Field wiring diagram for Sir Allan MacNab Secondary

Project segment	New NFPZ3000-2HE
Client/facility name	Sir Allan MacNab Secondary School
Facility address	145 Magnolia Dr
City, State, Zip	Hamilton, ON L9C 5P4
Client contact person	
Contact phone #	
Purchased by (if not client)	
Contact person	
Contact phone #	
Nederman project manager	Joe Hayes
Contact phone #	704-998-2635

Field wiring diagram final for the project with data on Nederman supplied components - FOR APPROVAL

Top Down Power and motor wiring diagram.

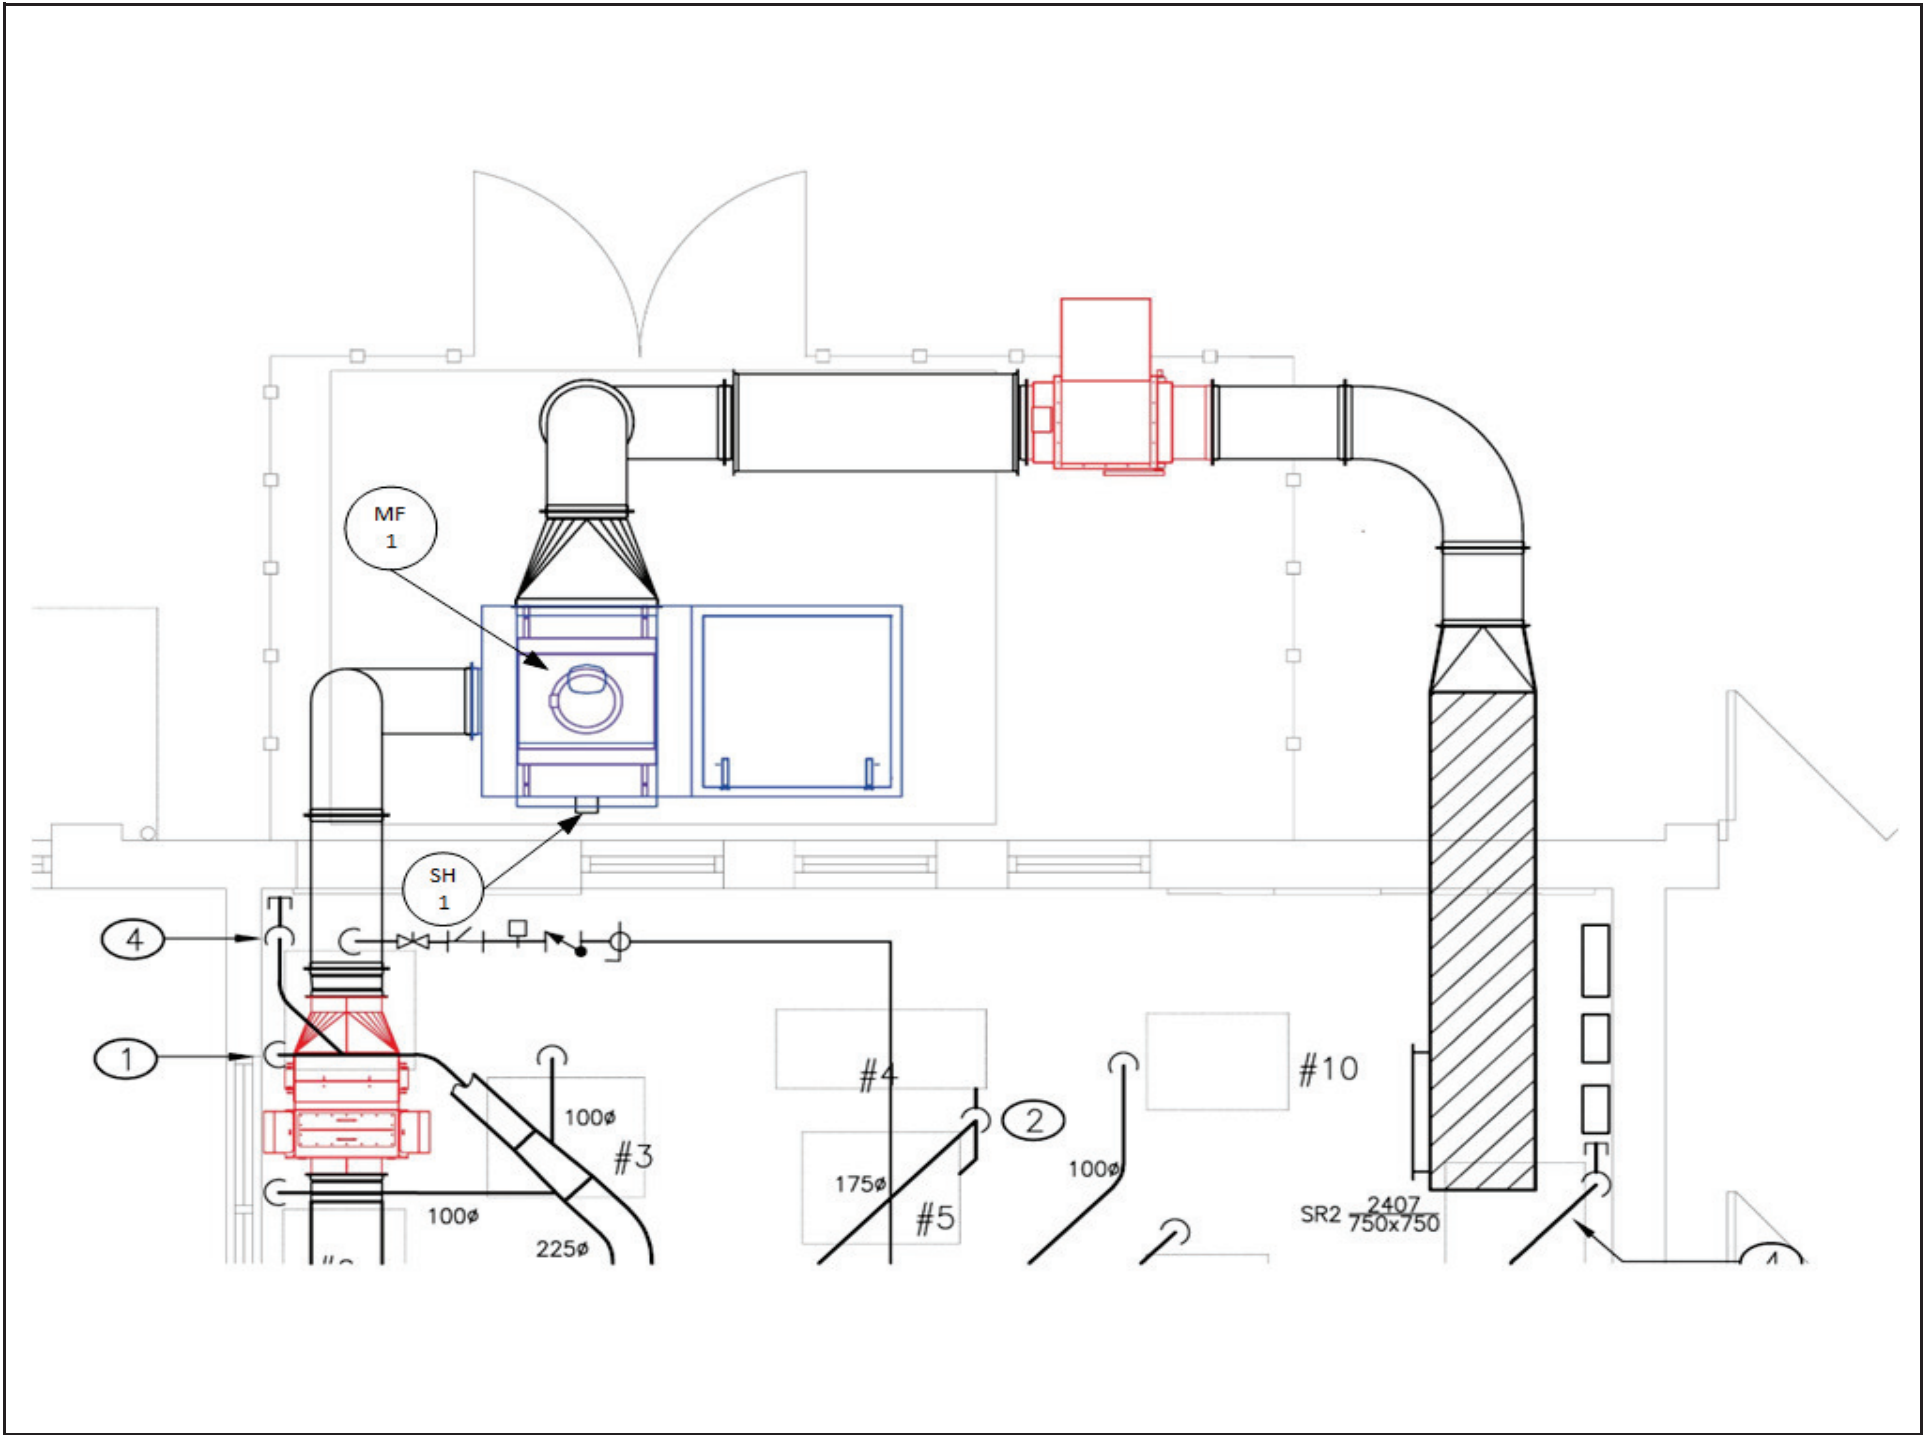
THE DUST COLLECTOR SHALL BE INSTALLED 1200M AWAY FROM WALL
